TECHNICAL BULLETIN

Intermittent High Idle – Replace Throttle Return Springs

19-33

MODEL XJ12 (6.0L) 1994 MY

ILLUSTRATION 1

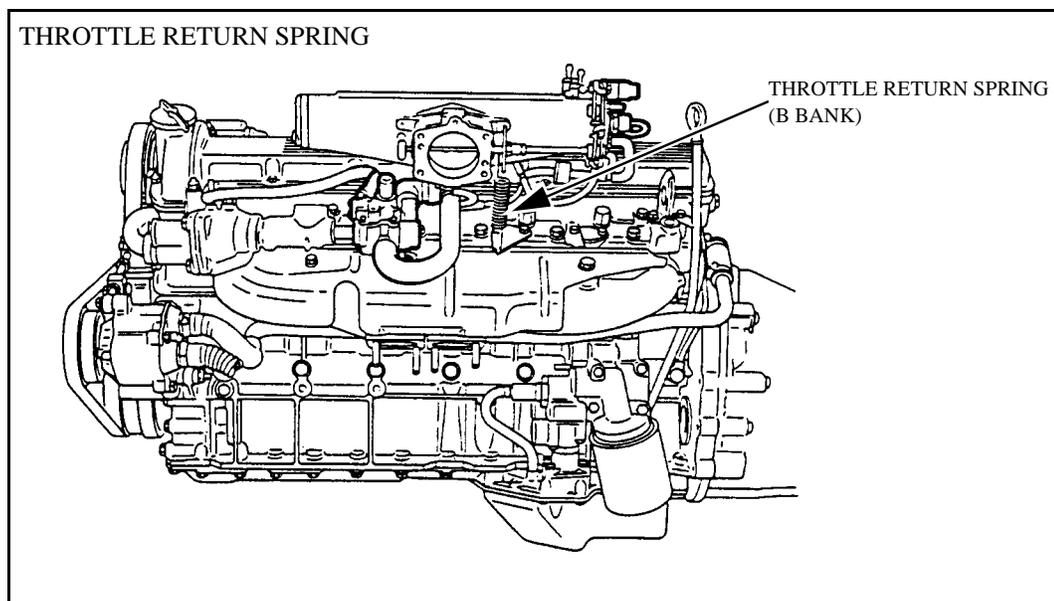
Some 1994 MY XJ12 Sedan Range vehicles may experience an intermittent high idle speed of approximately 900 rpm (normal idle speed, 750 rpm in neutral). This condition occurs when slowly returning the throttle to the idle position.

Revised throttle springs with increased preload were installed on all 6.0L engines beginning with 1995 MY production.

If customers of 1994 MY XJ12 vehicles complain of intermittent high idle speed, replace the existing throttle return springs with two revised springs (part number NAC 3030AB) as follows:

1. Remove throttle return spring from the throttle body, Illustration 1.
2. Install the new spring first to the bracket, then to the throttle lever.
3. Repeat the procedure on the throttle body on the opposite bank.
4. Check for correct throttle return operation.
